MODEL:	TYPE:	SECTION/GROUP:	DATE:
E/J	Field Change Program	02 – Rear Axle Steering	March 6, 2019

Ref. MCI NHTSA Recall No.: 19V-027

Ref. MCI Transport Canada Recall No.: 2019-006

3. **Tag Axle Caster Adjustment Procedure:**

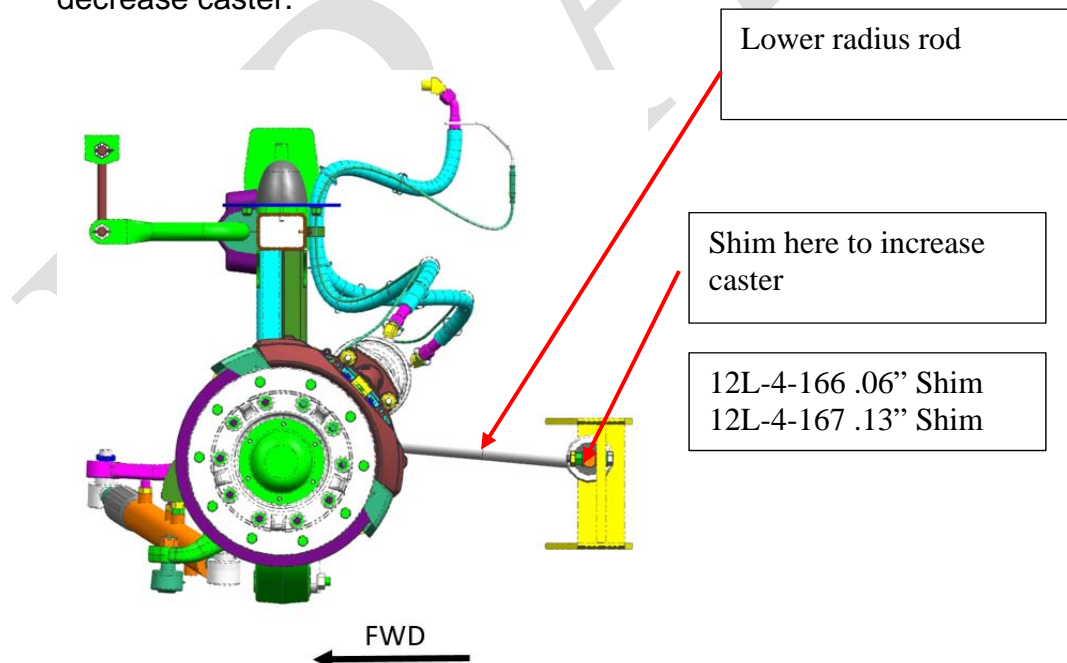
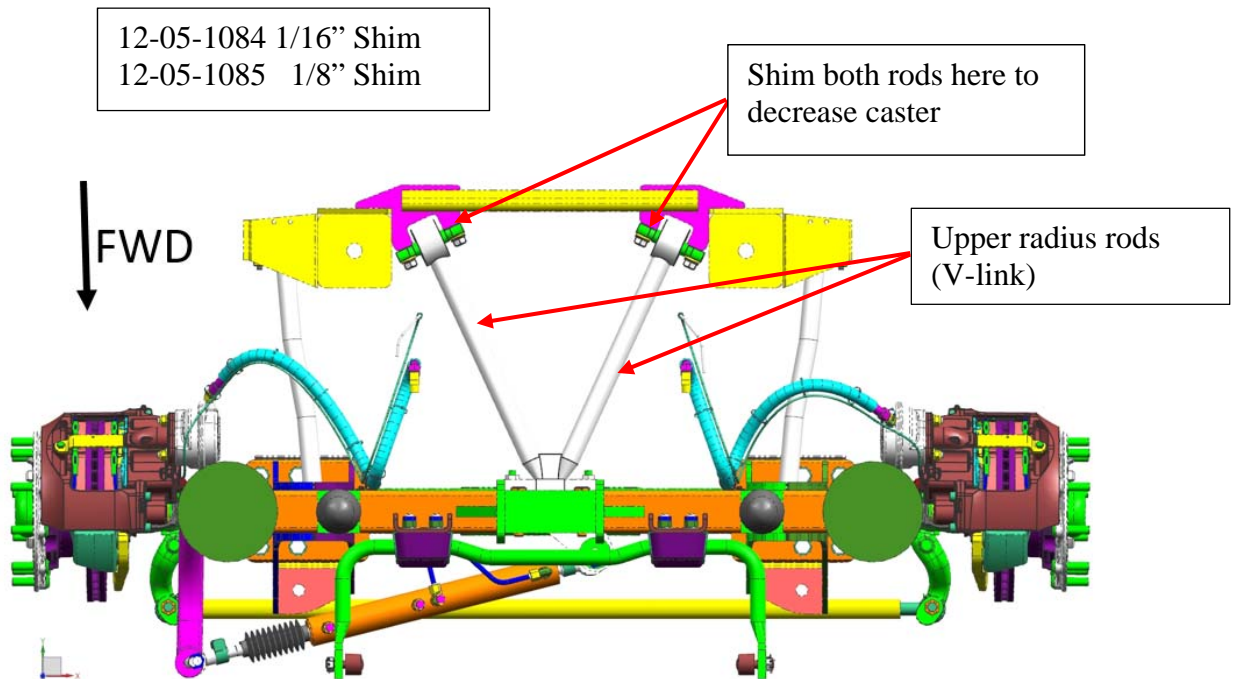
3.1 Measure the caster using a Hunter Engineering bus alignment machine or equivalent.

Tag axle caster should be nominally set at a positive 3 degrees. Acceptable range is positive 2 to 3.5 degrees.

If necessary, shim the radius rods to bring the caster readings within tolerance.

Shim the lower radius rods to increase the caster. Shim the upper radius rods to decrease caster.

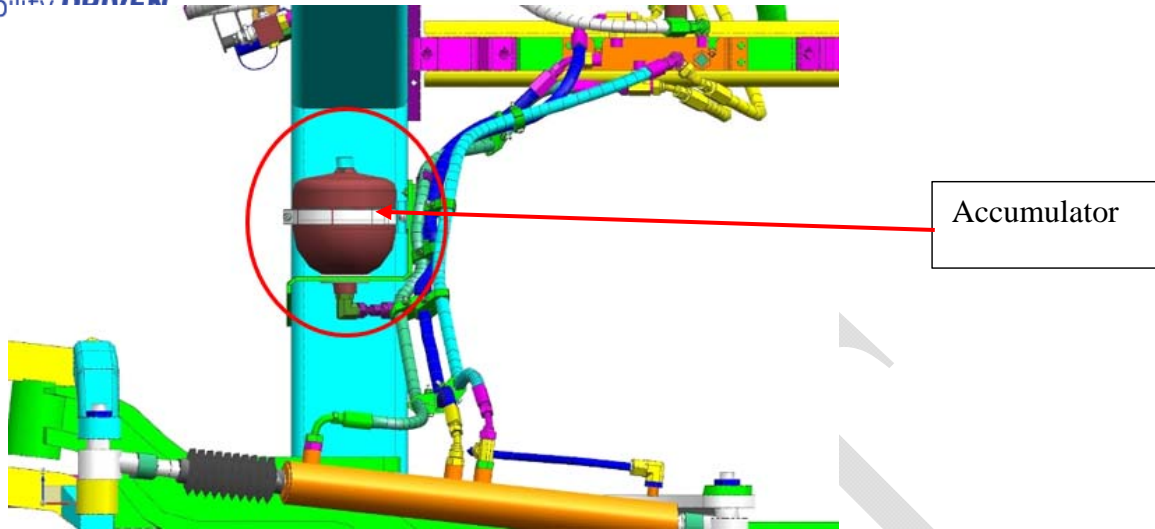
- a. Perform the visual inspections as given above.
- b. Start the coach and verify that the RAS low pressure tell-tale is not lit.

RAS System Overview

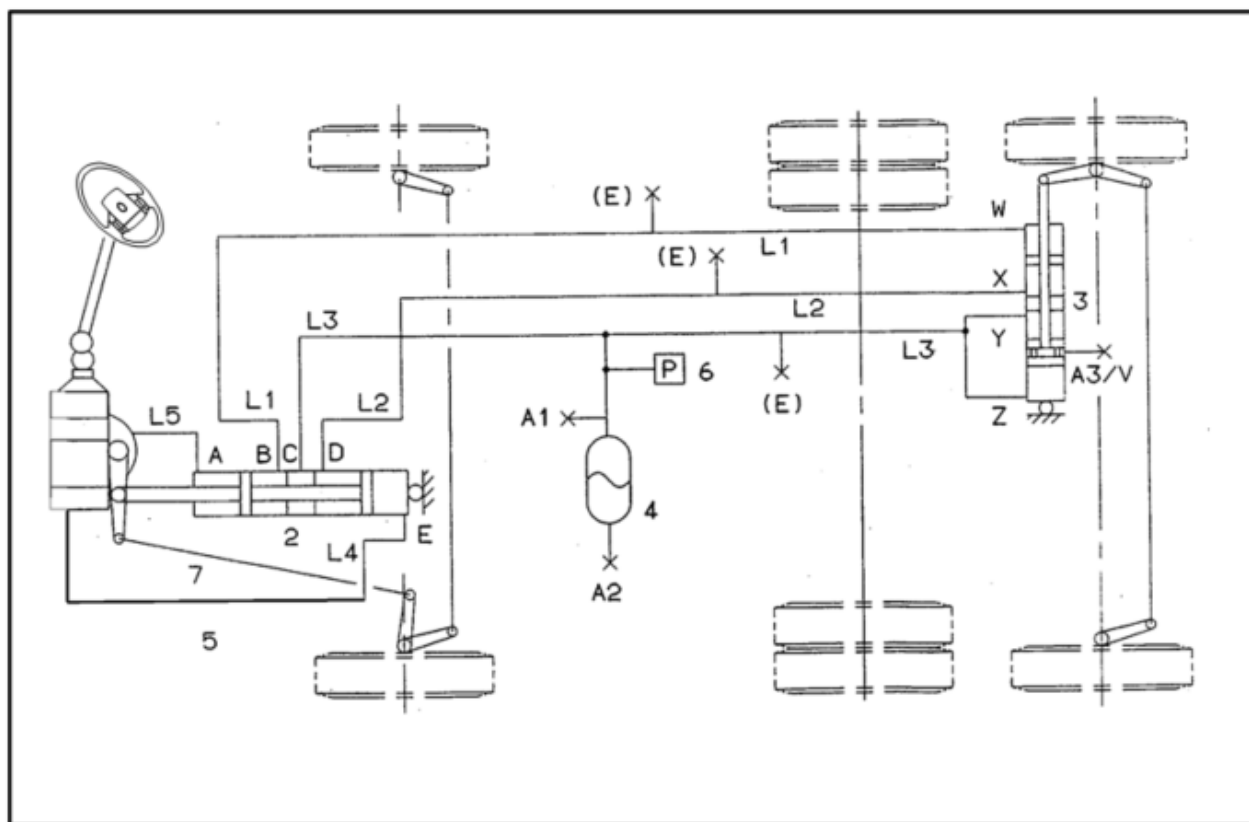
- a. To check the RAS system accumulator, the RAS system pressure must first be lowered to approximately zero by connecting to L1, L2 and L3 ports and draining the fluid.

- b. Then, remove the cap on top of the accumulator and loosen slightly the hexagon socket head plug that is under the cap previously removed. Connect the accumulator pressure measurement, tool part number T20-1255 using adapter fitting T19-1155, to the top of the accumulator. Using the tool connection to the accumulator, slightly loosen the hexagon socket head screw until the accumulator pressure is being read by the gage on the pressure measurement tool.

- c. If the pressure reading is less than 20 psi, replace the accumulator. If the pressure in the accumulator is above 20 psi, charge the accumulator using the tool previously attached to accumulator with dry nitrogen to 145 to 160 psi.

- d. Allow 5 minutes for the gas temperature to equalize and recheck the accumulator pressure and adjust the pressure if necessary. Again wait 5 minutes and check the accumulator pressure. If the accumulator pressure is dropping, replace the accumulator since it has an internal leak. If the accumulator pressure is holding pressure, tighten the hexagon socket plug using the accumulator tool and then remove the accumulator tool. Torque the hexagon socket plug to 18 ft-lbs(25 nm)
